NOTICE OF APPROVAL

Planning Case #: Design Study 24228
Owner Name: GIVENS TROY & SHARYL TRS
Case Planner: Marnie R. Waffle, AICP, Principal Planner
Date Posted:
Date Approved: 11/06/2024
Project Location: SE Corner of 5th & Torres
APN #: 010092012000 BLOCK/LOT: 60/W 1/2 OF LOTS 2 AND 4

Project: DS 24-228 (Givens)

DS 24-228 (Givens) authorizes the approval of Design Study Applications (**DS 24-228, Givens**) for the modifications to Design Study approval DS 22-226 (Givens) located at SE Corner of 5th and Torres in the Single-Family (R-1) District. APN: 010-092-012

PROPOSED WEST (FRONT) ELEVATION: TORRES STREET

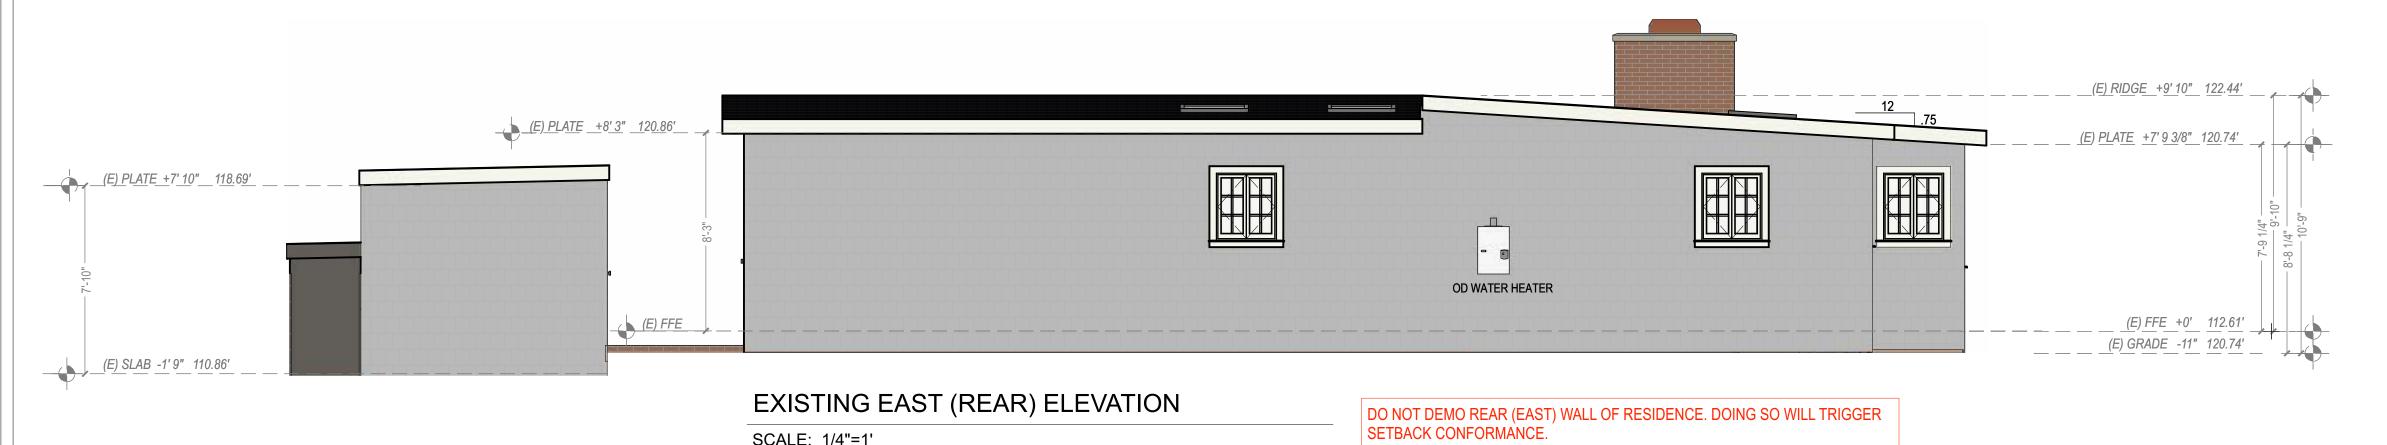
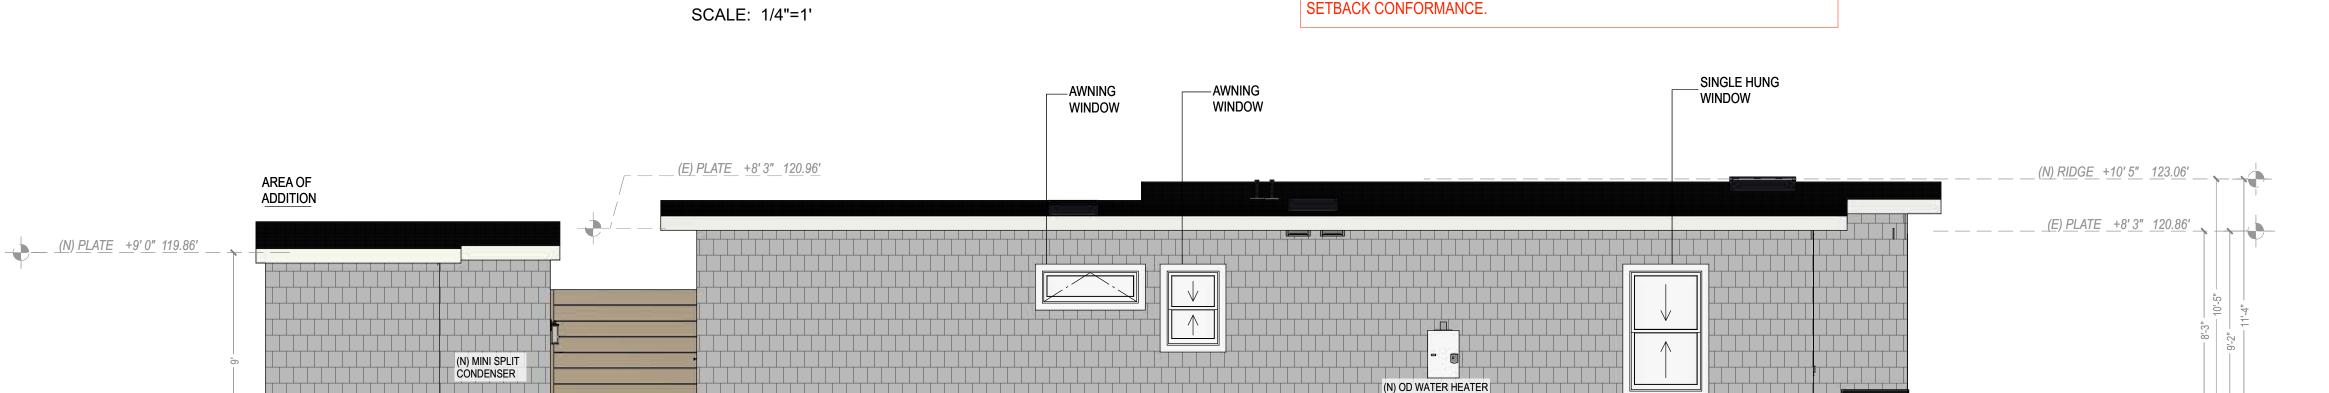
<u> BUILDING CHANGE ORDER #1 - JulY 2024</u> SOUTH FACING PRIMARY SUITE MULLED UNIT WIDENED

HARDSCAPE RECONFIGURED: COURTYARD ENLARGED. DRIVEWAY STRAIGHTENED. FENCE VISIBLE FROM STREET (NO CHANGE TO WOOD OR SPACING), GATE INTO COURTYARD

REFLECTED CEILING PLAN

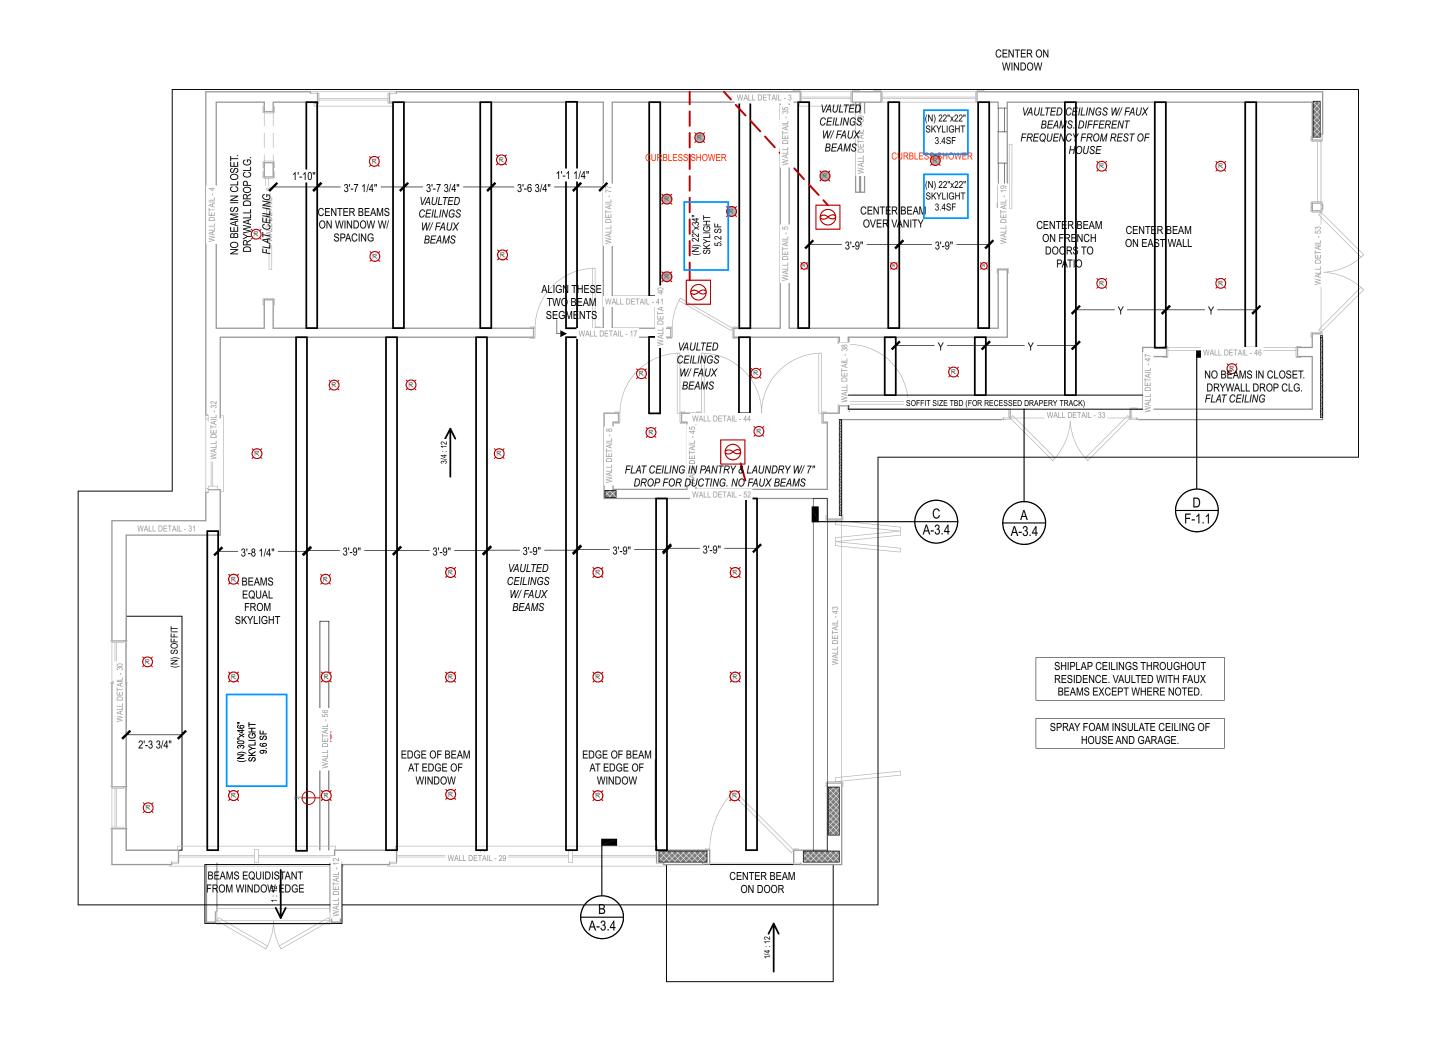
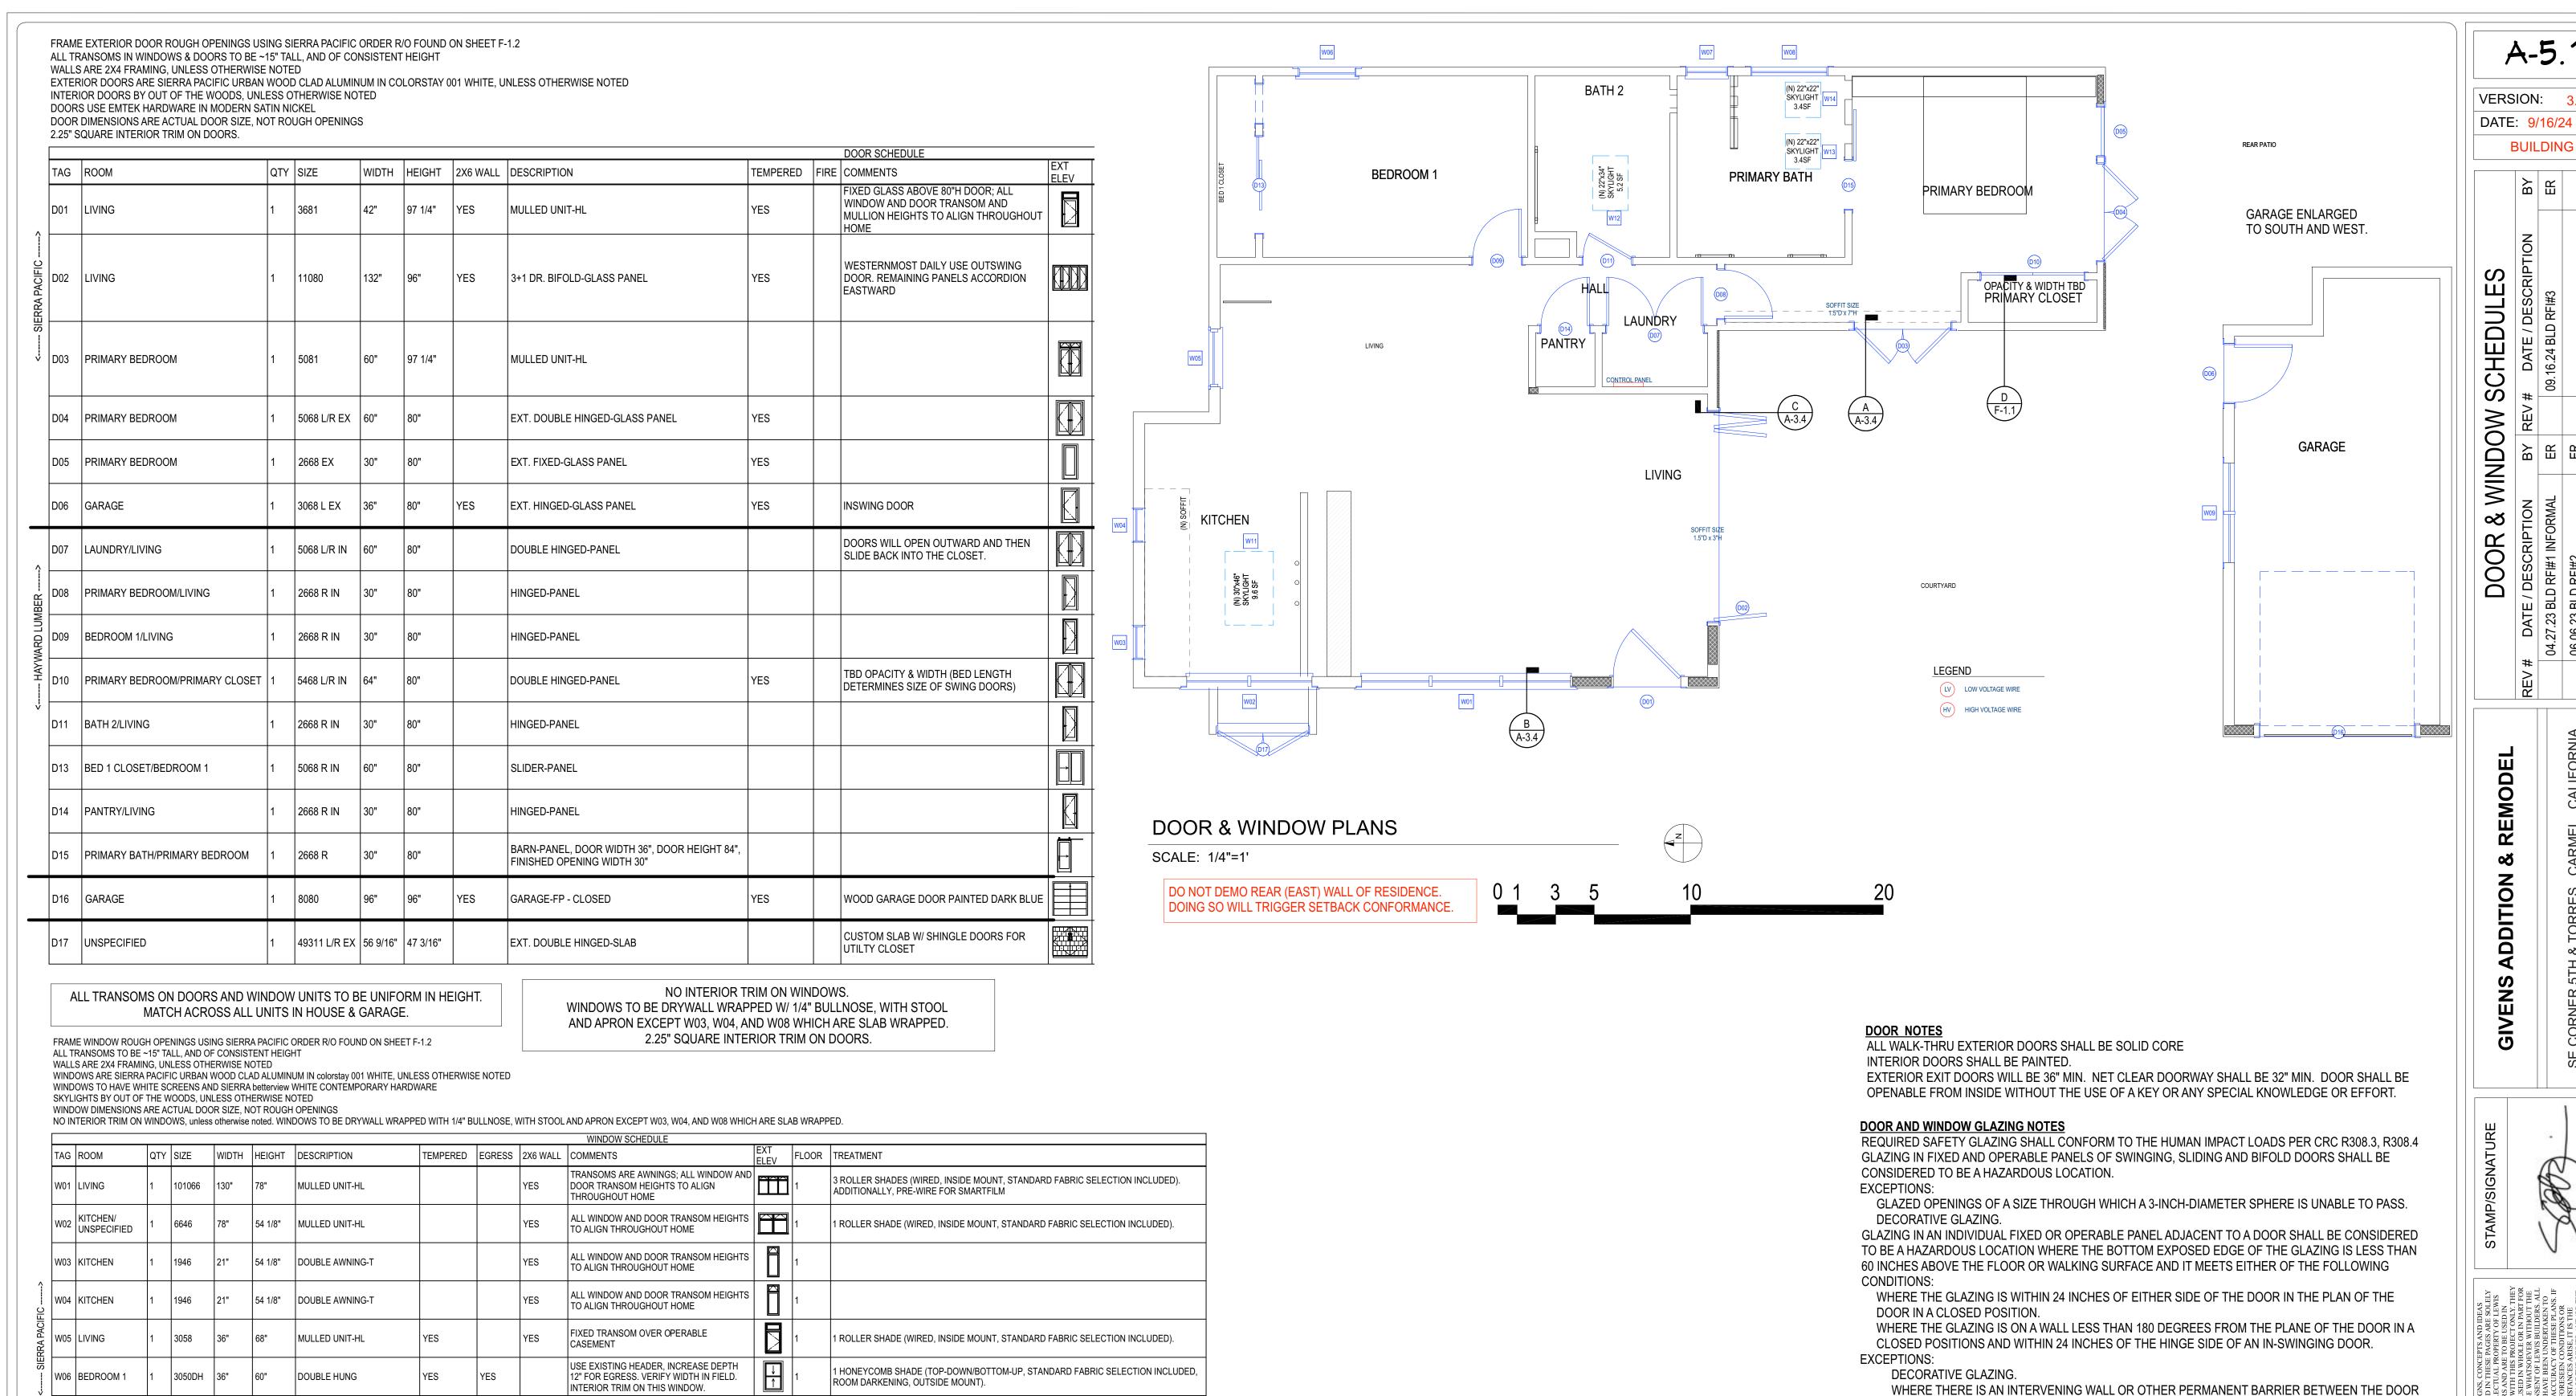
BEAM SIZE ADJUSTMENT: 5.5"W x 7"H. PRIMARY BEDROOM BEAMS ADDED BACK IN AND POSITIONING ADJUSTED.

AV PLAN

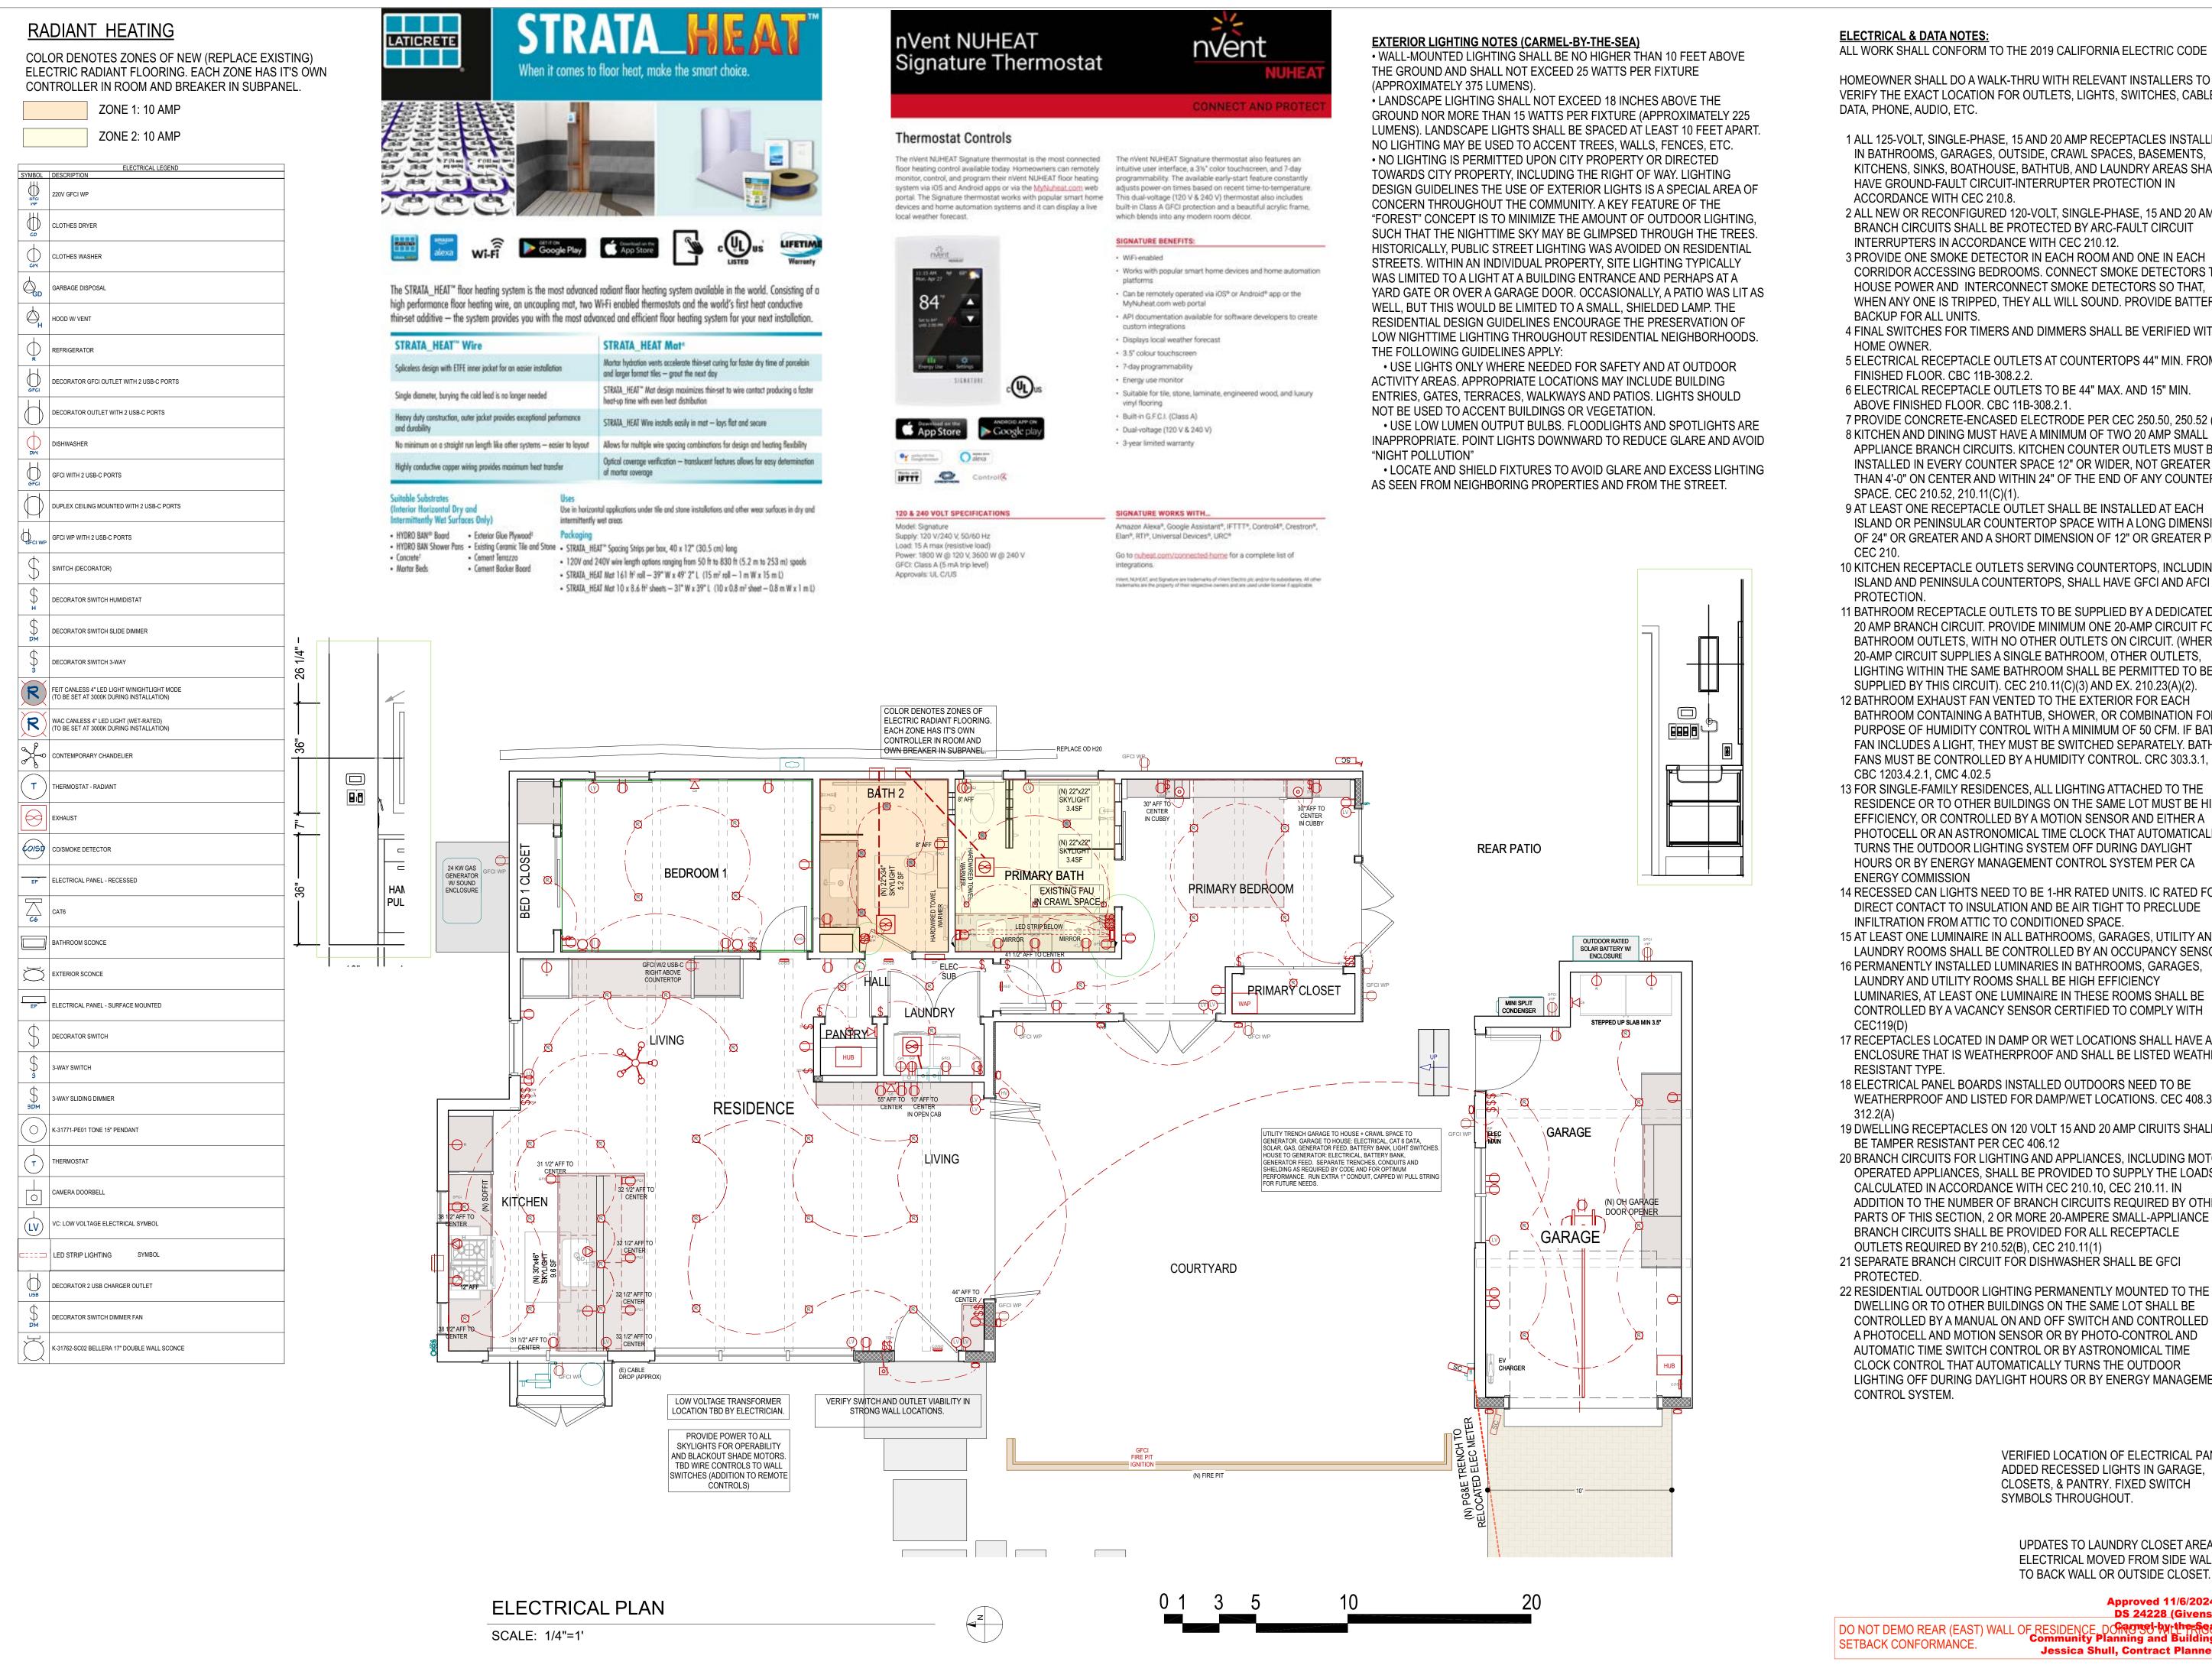
> VERIFIED LOCATION OF ELECTRICAL PANEL. ADDED RECESSED LIGHTS IN GARAGE, CLOSETS, & PANTRY. FIXED SWITCH SYMBOLS THROUGHOUT.
